UNITED STATES PATENT AND TRADEMARK OFFICE

APPLICATION NO.	FILING DATE	FIRST NAMED INVENTOR	ATTORNEY DOCKET NO.	CONFIRMATION NO.
10/004,803	12/07/2001	Norihide Ooyama	011659	7776

Office Action Summary

DETAILED ACTION

Figures 1-2 below illustrate structures of the pre-sealed and sealed solid electrolyte cell, respectively.

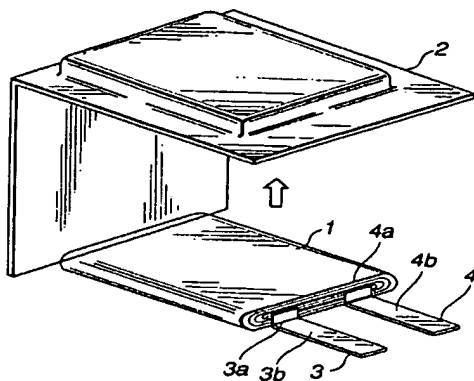
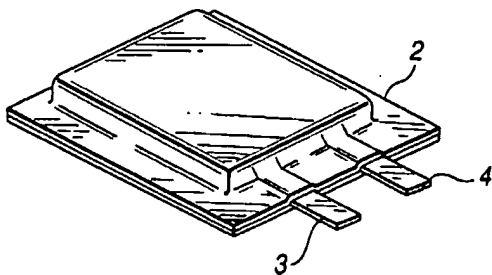
The EP'959 reference discloses a non-aqueous electrolyte cell in which an unit cell is housed in an exterior packaging material of a laminated film and encapsulated on heat fusion; said unit cell is a wound assembly of elongated positive and negative electrodes each being constituted by a current collector and a layer of an active material formed thereon (claim 1/page 9, lines 14-24). It is disclosed that the unit cell comprises a solid electrolyte or gel-like electrolyte arranged between a layer of an active material of a positive electrode and a layer of an active material of a negative electrode (*the separator*) (SECTION 0017). It is also disclosed that the unit cell is accommodated in a packaging material 2 of a laminated film obtained on molding with deep drawing in meeting with the shape of the unit cell 1, and the rim portion of the resulting assembly is heat-fused for hermetic sealing (SECTION 0017). It is disclosed that the exterior package material of the laminated aluminum film is then folded back on itself along its mid line to enclose the unit cell. The opened three-sides of the exterior packaging material is then sealed using a heat-sealing devices (SECTION 0063). It is noted that aluminum is a malleable metallic element, that is, capable of being extended or shaped by beating or by

pressure, or capable of being altered or deformed by outside forces, that is to say, aluminum has the capacity for adapting shape changes.

The EP'959 reference teaches that each elongated positive and negative electrodes is constituted by a current collector and a layer of an active material formed thereon (claim 1/page 9, lines 14-24). Further, the EP'959 discloses that the negative and positive terminals are comprised of a current collector 11a and 12a, on each side of which is formed a layer of an active material for the negative and positive terminals 11b and 12b. These layers 11b and 12b are partially removed to expose the current collectors 11a and 12a and the negative terminal leads 13

and 14 are mounted on the exposed portion of the current collectors 11a and 12a (SECTIONS 0023-0024). Thus, it is understood that active material layers are formed on the surfaces of the curved portions positioned on outermost periphery of each positive and negative electrode because active material layers are only removed at the current collector site where the terminal leads are mounted.

FIG.8

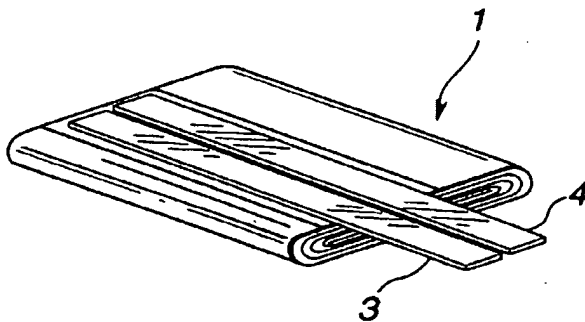
It is further disclosed that the wound assembly is flat-shaped (claim 2/page 9, line 29). Figure 8 shows an unit cell having a terminal lead and a positive terminal lead arranged outside of the winding member. *From Figure 8 below it is apparent that the positive and negative electrode are wound-up by having plane portions and curved portions and having a band shape identical to the instant claims.*

Comparative Example 2 and Figure 8 above show both the negative terminal lead 3 of the negative terminal and the positive terminal lead 4 of the positive terminal placed on the outer side of the winding electrode structure. It is disclosed that the resulting wound assembly is

sheathed in an aluminum laminate film as an exterior packaging and then heat sealed (SECTION 0067/ COMPARATIVE EXAMPLE 2).

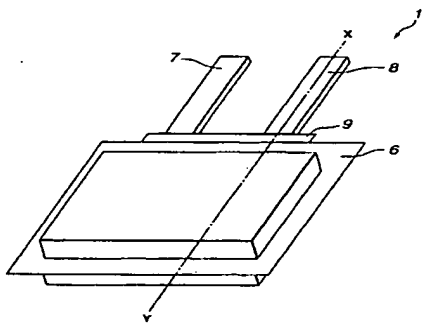
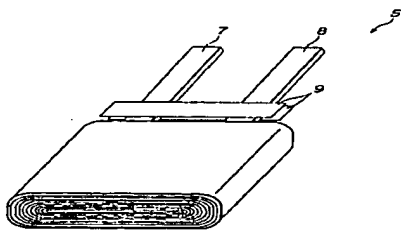
The EP'611 discloses that as shown on Figures 2 and 4, the positive electrode lead 7 and the negative electrode lead 8 are sandwiched by the sealing portion in which is the periphery of the casing film. Moreover, a resin film 9 is disposed in each of the portions in which the positive-electrode lead 7 and the negative electrode lead 8 are brought into contact with the casing film 6 (SECTION 0022, particularly, page 4, lines 14-16).

Further, as is apparent from the Figures 2 and 4 above, the battery element is accommodated in a recessed portion of the casing film, and the electrode leads are placed on its plane portion and the cell is sealed.
